**NPDES PERMIT FACT SHEET  
INDIVIDUAL INDUSTRIAL WASTE (IW)  
AND IW STORMWATER**

Application No. PA0043672  
APS ID 343285  
Authorization ID 1225057

Applicant Name	<u>General Dynamics Ordnance &amp; Tactical System (OTS) PA Inc.</u>	Facility Name	<u>General Dynamics OTS PA Inc</u>
Applicant Address	<u>200 E High Street</u> <u>Red Lion, PA 17356-1426</u>	Facility Address	<u>200 E High Street</u> <u>Red Lion, PA 17356-1426</u>
Applicant Contact	<u>Harry Smith</u>	Facility Contact	<u></u>
Applicant Phone	<u>(717) 246-8208</u>	Facility Phone	<u>(717) 246-8208</u>
Client ID	<u>148815</u>	Site ID	<u>456525</u>
SIC Code	<u>3489</u>	Municipality	<u>Red Lion Borough</u>
SIC Description	<u>Manufacturing - Ordnance And Accessories, Nec</u>	County	<u>York</u>
Date Application Received	<u>April 16, 2018</u>	EPA Waived?	<u>Yes</u>
Date Application Accepted	<u>April 20, 2018</u>	If No, Reason	<u></u>
Purpose of Application	<u>NPDES renewal for discharge of stormwater and treated groundwater.</u>

Figure 5. Revised Site Plan showing locations of Outfalls 002 and 003 (received via email on 06/06/2022)

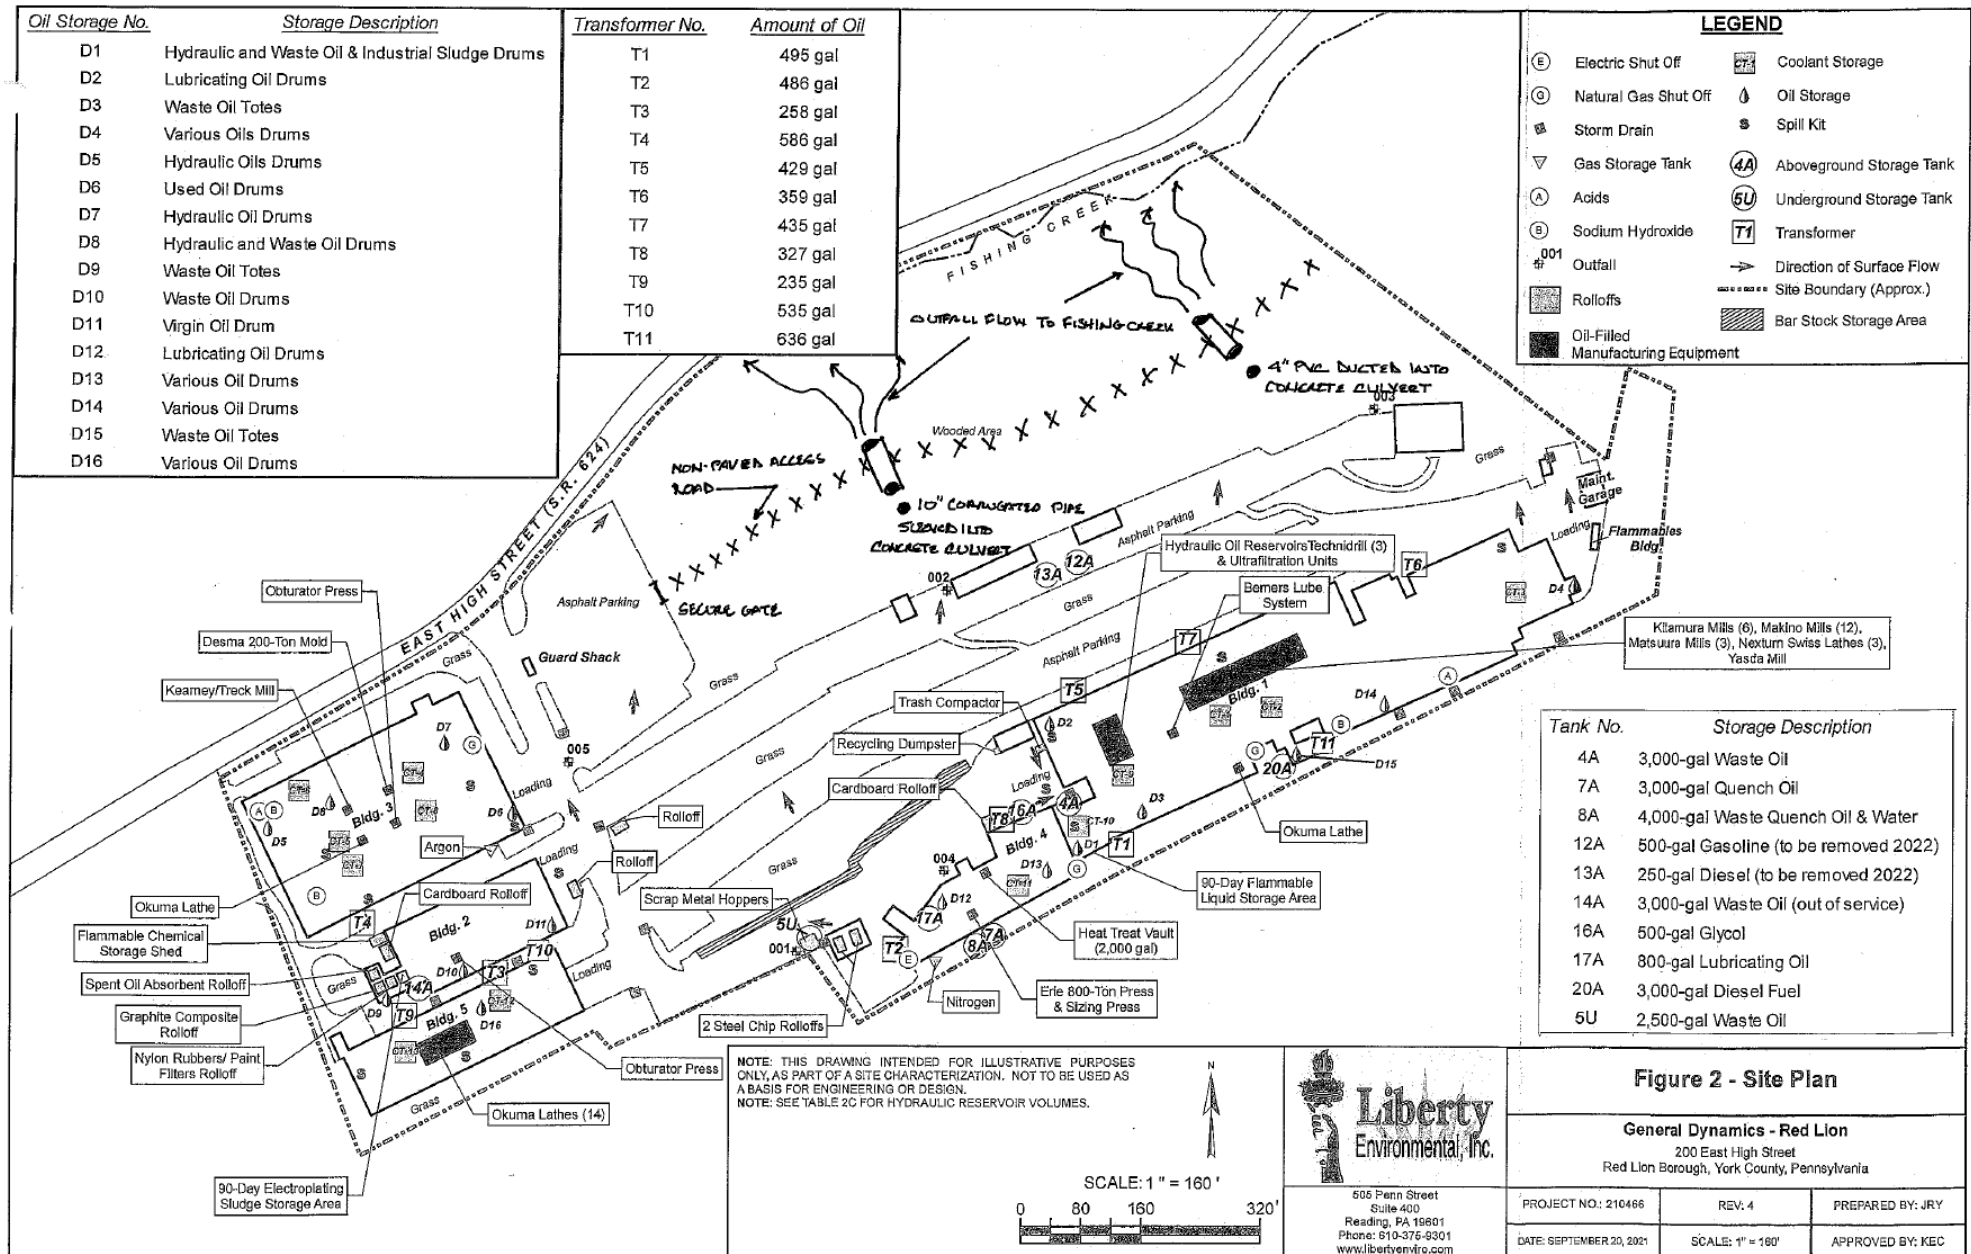
**5/2/2022** – Follow up email to the site visit was sent asking for him to research what happened to the effluent from both AST1 (Outfall 002) and AST2 (Outfall 003). And if the effluent from the ASTs was discharged at the site as indicated in the previous NPDES Permit No PA0043672, I asked for a map showing the locations of Outfall 002 and Outfall 003 and the likely flow path to the nearest surface water. I also asked for an update on the line drawing/process flow diagram for the facility, which was estimated to be available by June 7, 2022; and the additional stormwater sample results for Outfalls 002 and 005.

- i. Verify where the effluent from AST1 would be (and has been) disposed / discharged in the unlikely scenario that AST1 would need to be restarted for additional treatment of the groundwater.

- i. Verify where the effluent from AST2 would be (and has been) disposed / discharged in the unlikely scenario that AST2 would need to be restarted for additional treatment of the groundwater.

- On 6/6/2022, a revised Site plan (Figure 5) was received showing the discharge location for Outfall 002 and subsequent outfall flow to Fishing Creek.

- Using the revised Site Plan (Figure 5) and eMapPA, the approximate location for Outfall 002 is 39.905 N / -76.602 W.

- b. Since Outfalls 002 and 003 cannot be at the same location and the Latitude and Longitude provided are not valid, the latitude and longitude listed above is the location of AST2, and not the location of the discharge from AST2.
- c. On 6/6/2022, a revised Site plan (Figure 5) was received showing the discharge location for Outfall 003 and subsequent outfall flow to Fishing Creek.
- d. Using the revised Site Plan (Figure 5) and eMapPA, the approximate location for Outfall 003 is 39.905 N / -76.600 W.

Figure 6. Water and waste water process flow diagram (received via email on 06/06/2022)

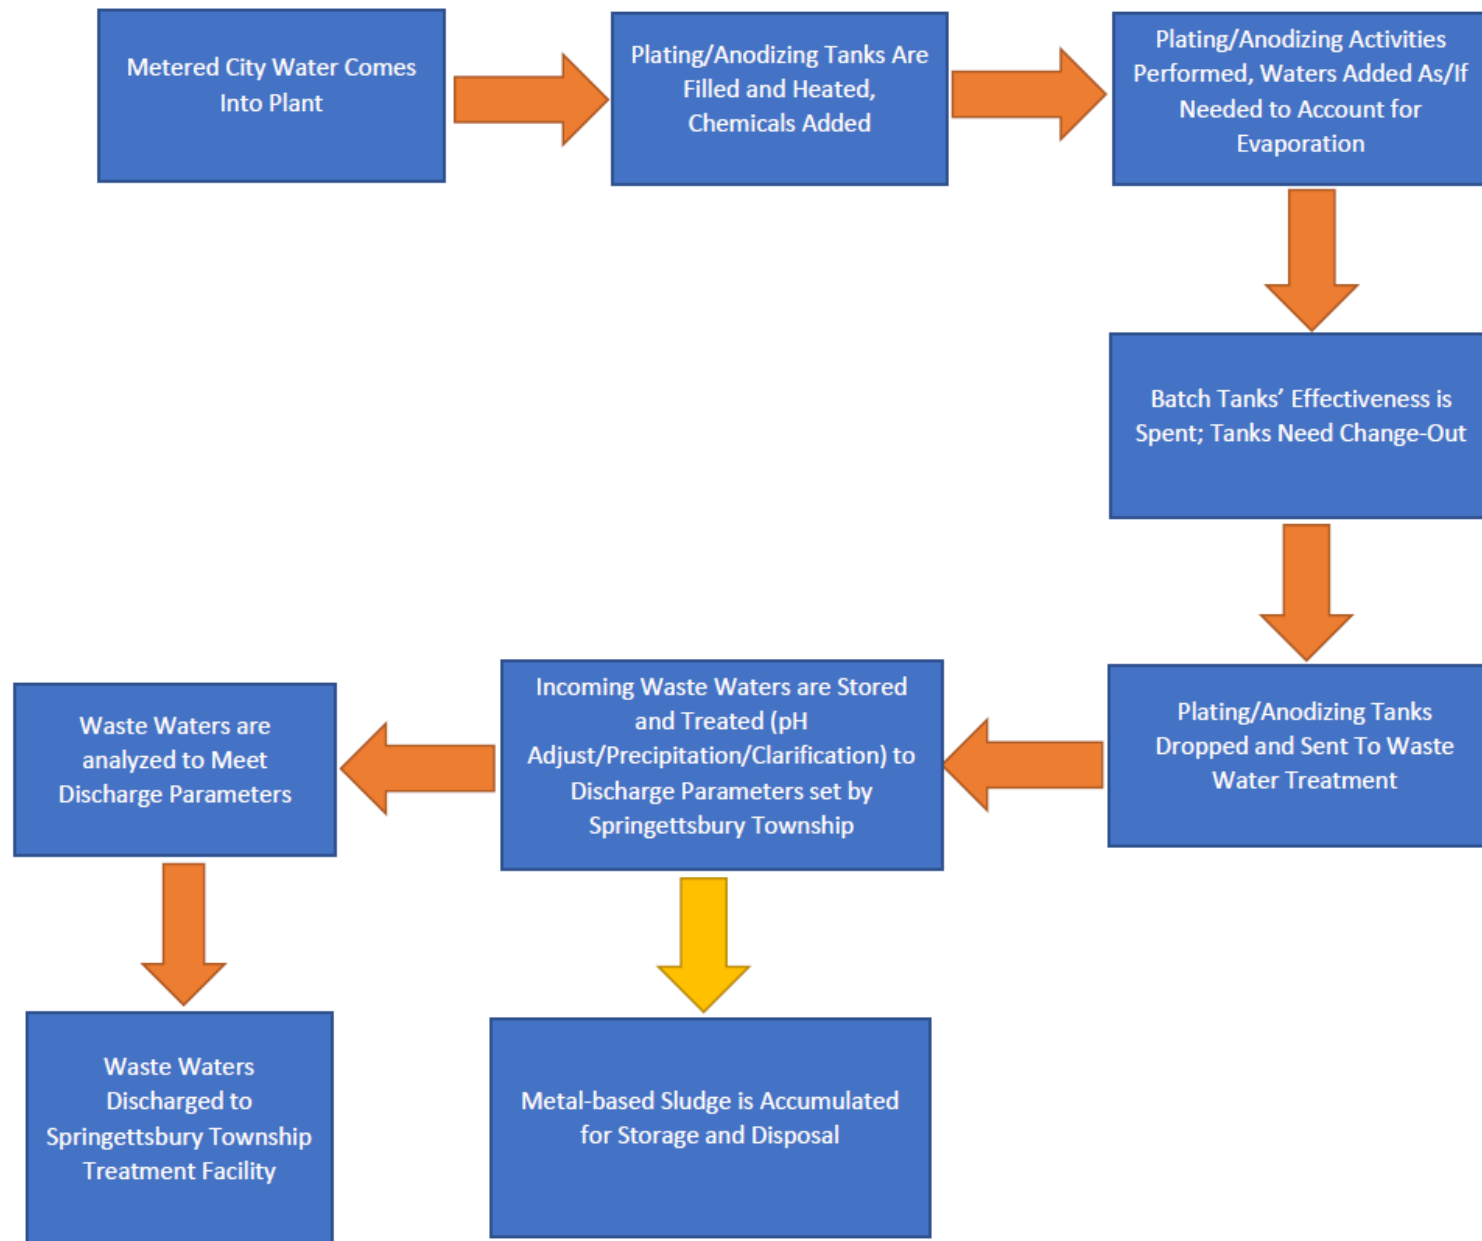
- a. In order to help me better understand the groundwater remediation system, please provide a water balance diagram (from extraction wells to outfall) and a design diagram for the existing groundwater treatment system.

- b. Site Drawing and water balance. Not included. Submit a Line drawing / process flow diagram illustrating the flow of water and wastewater through the facility, with a water balance diagram listed as Item 10 on the checklist and required by the application

**6/6/2022** – DEP received 3 separate email from Mr. Smith providing me with the additional information I had requested on 5/2/2022 including written descriptions and details regarding Outfalls 002 and 003; a site plan showing the locations of Outfalls 002 and 003 including “path” to the nearest surface waters (Figure 5); and a water and waste water process flow diagram (Figure 6). And an update that he’s still awaiting stormwater sampling results and will transmit upon receipt. [Attachment F – saved as a PDF]
